# 1973 Corvette: Service Bulletin: Exhaust Manifold Heat Shielding

**Chevrolet  
 Dealer  
 Service  
 Technical  
 Bulletin**

73-T-8  
 Number:  
 Ia  
 Section:  
 Jan. 3, 1973  
 Date:

Subject: EXHAUST MANIFOLD HEAT SHIELD -  
 1973 CORVETTE WITH 350 CU. IN.  
 ENGINE WITH AIR CONDITIONING

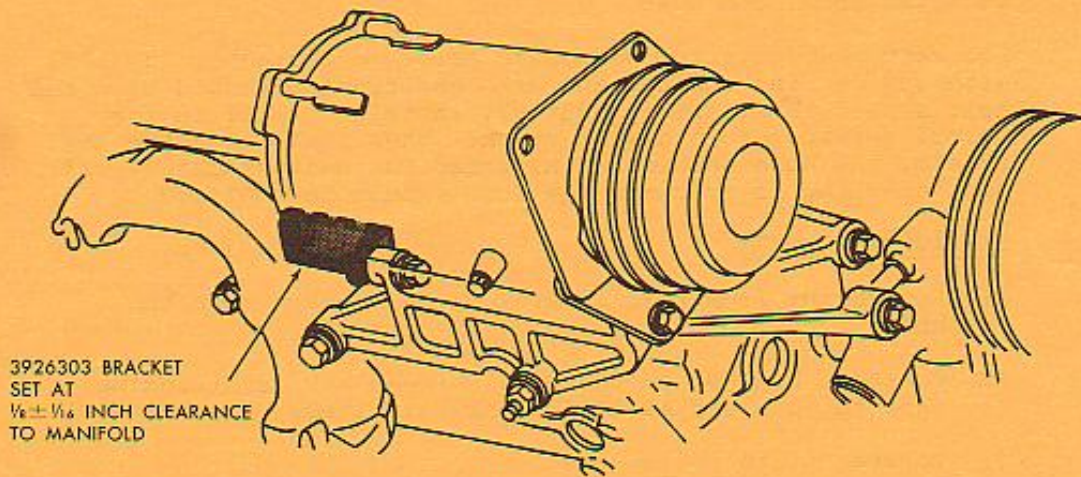
Some early production 1973 Corvettes equipped with 350 cu. in. engines and air conditioning may experience air conditioning hose damage due to close proximity of the exhaust manifold.

Corvettes assembled after September 13, 1972, have a heat shield installed between the hose and the manifold to protect the hose from heat.

For service, Corvettes assembled prior to September 13, 1972, with 350 cu. in. engines and air conditioning should have the heat shield, Part Number 3926303, installed while in for normal service or in dealer stock. When installing the heat shield, the hose should be inspected for heat cracking. If heat cracking is evident, the hose should be replaced.

- 1) Remove nut from rear compressor to bracket mounting bolt.
- 2) Position bracket on bolt and between air conditioning suction hose and manifold as illustrated.
- 3) Torque nut to 25 ft. lbs.
